PLANNING COMMISSION STAFF REPORT

PROJECT 74 – DESIGN PLAN

REQUEST: Requesting approval from the Clermont County Planning Commission for Project 74 – Design Plan

DESIGN PLAN	
Project Number	25488.02
Drawing Scale	1" = 100'
Sheet Number	1
File Number	25488

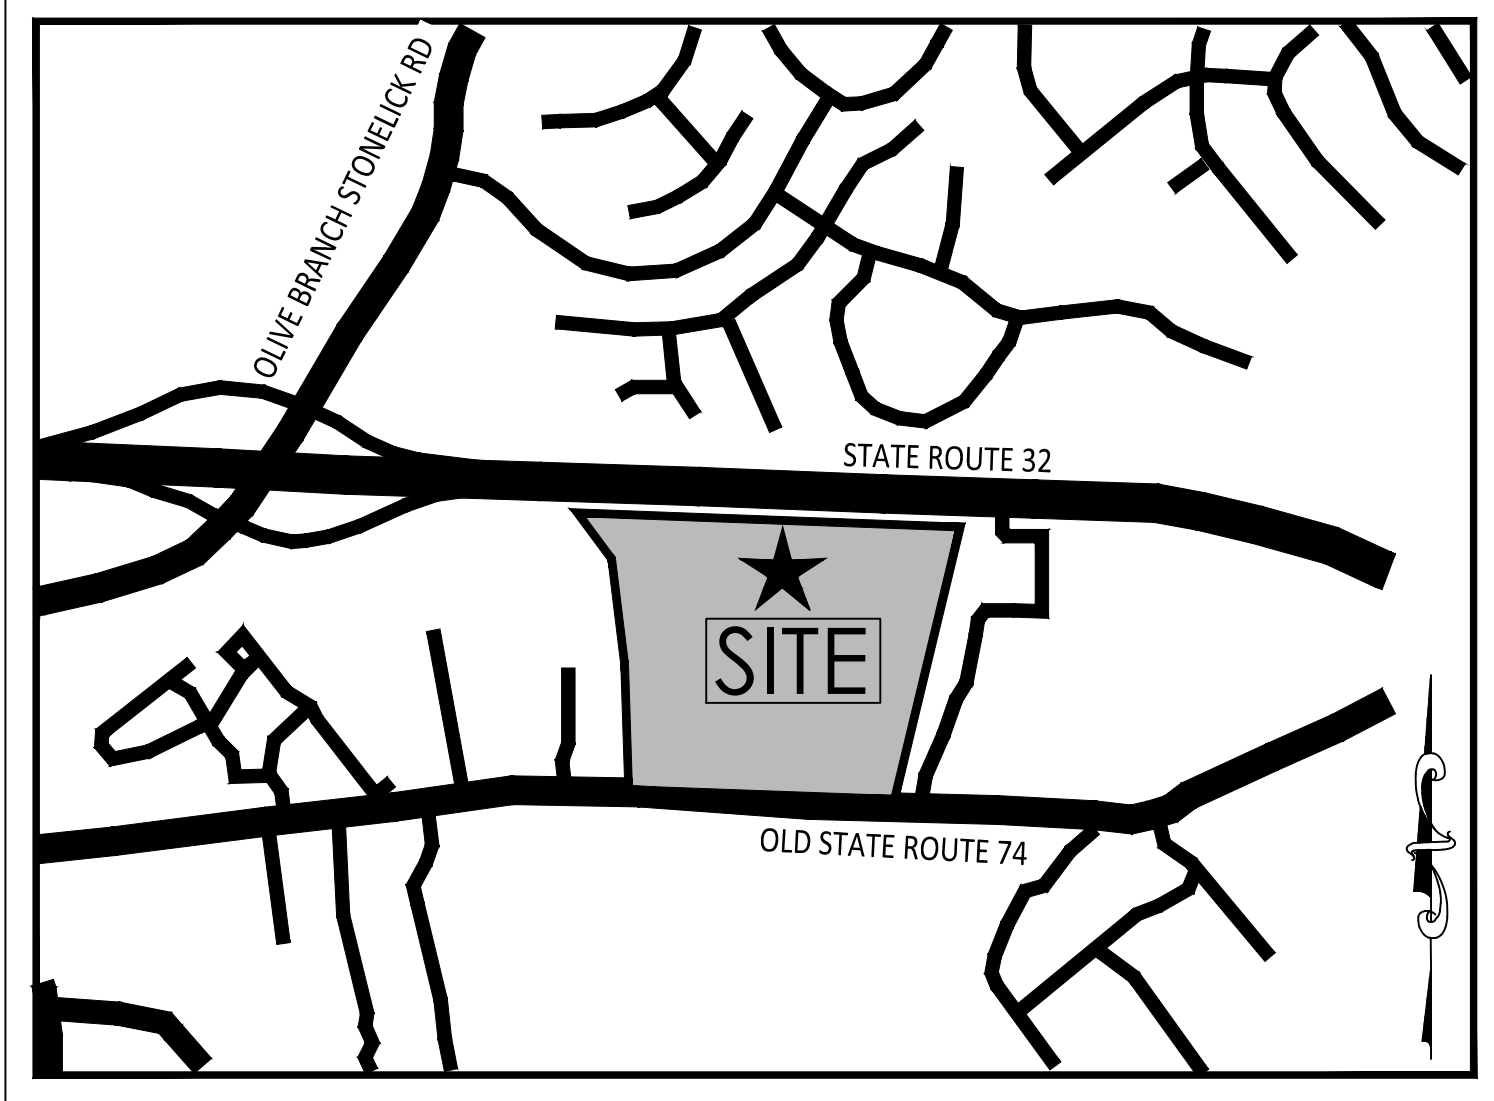
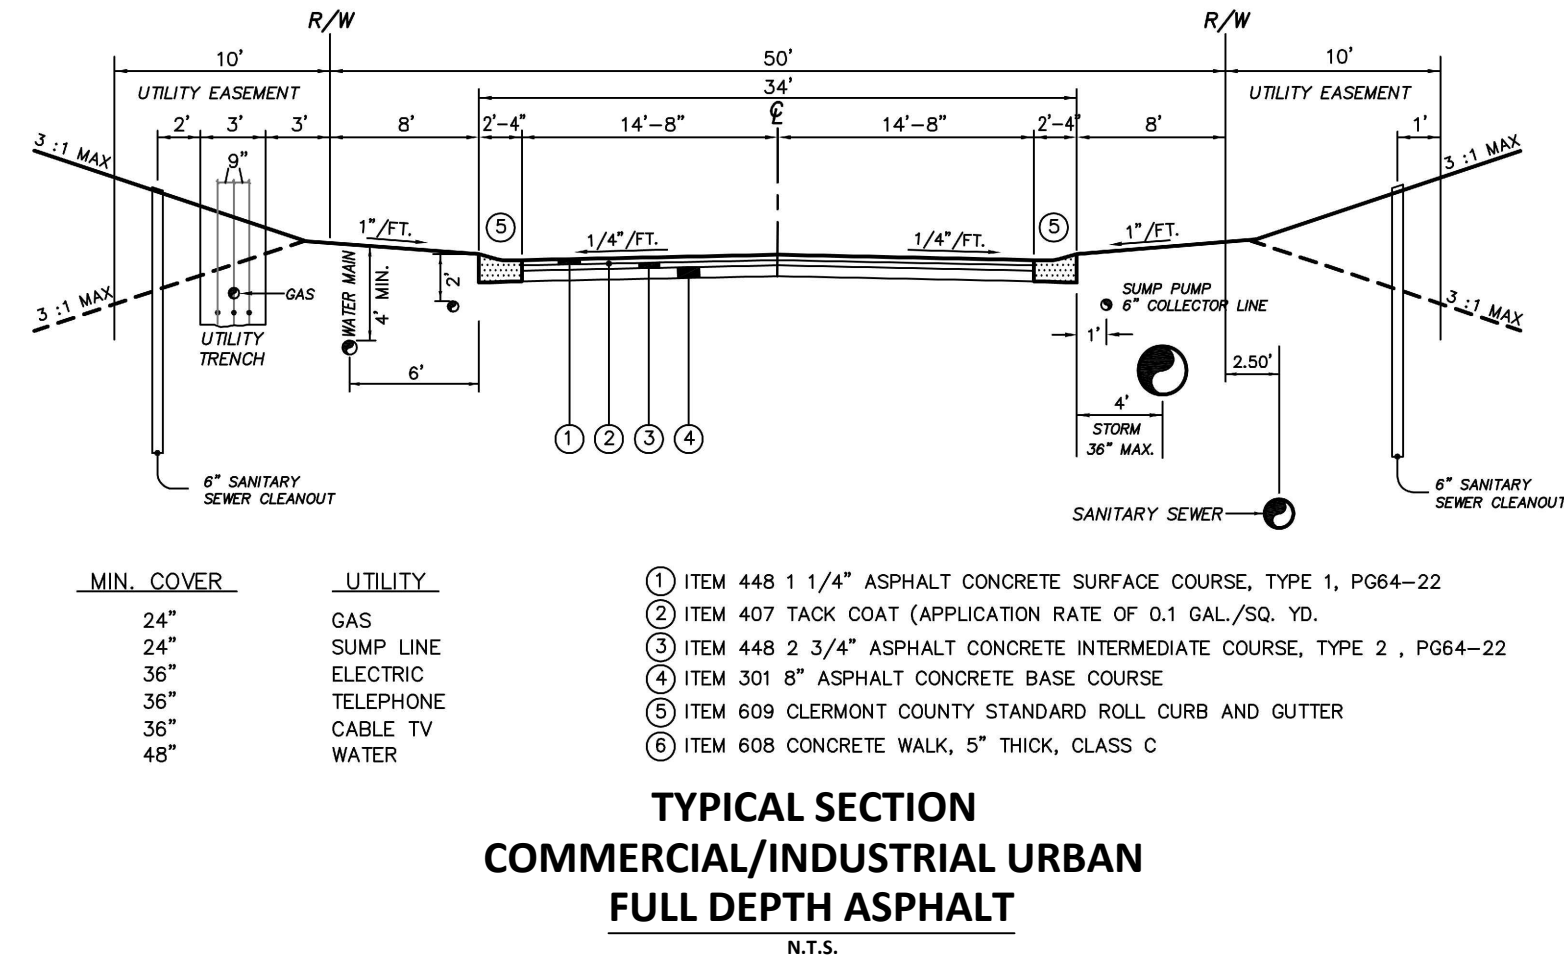
1. The Storm Water Management Maintenance Note needs to be revised. Remove the reference to ‘Dedication to Clermont County’ from the note. Currently the accepted maintenance options are a Home Owners Association or a Storm Water District.
2. A proper street name needs to be provided for the proposed road upon the plans.
3. A Traffic Impact Analysis needs to be provided for the proposed development.
4. A general reminder regarding roadway geometry; the minimum allowable street grade is 0.4%, maximum street grade is 12% (10% preferred), and the minimum centerline curve radius is 200’.

1. Label sanitary easements as “public sanitary sewer easements” coming from the northwest and down on OLD SR 74 by the western entrance. The existing labels do not label “public” or the easement.
2. Show fire hydrants easements around each fire hydrant.
3. Show connection method to existing water main with hot tap or cut in tee for both connections.
 - a. What size water meter will they need for the building? If above 2-inch or needs fire system a tee with valve is needed, install in water main with valve for ease of install.
4. What is the sanitary sewer size on this project?
5. Label clearly on the construction plans the lengths of sewer between manholes.

1. A swale will be needed to direct runoff from the storm sewer outlet near the southern portion of the property to the stormwater management basin.
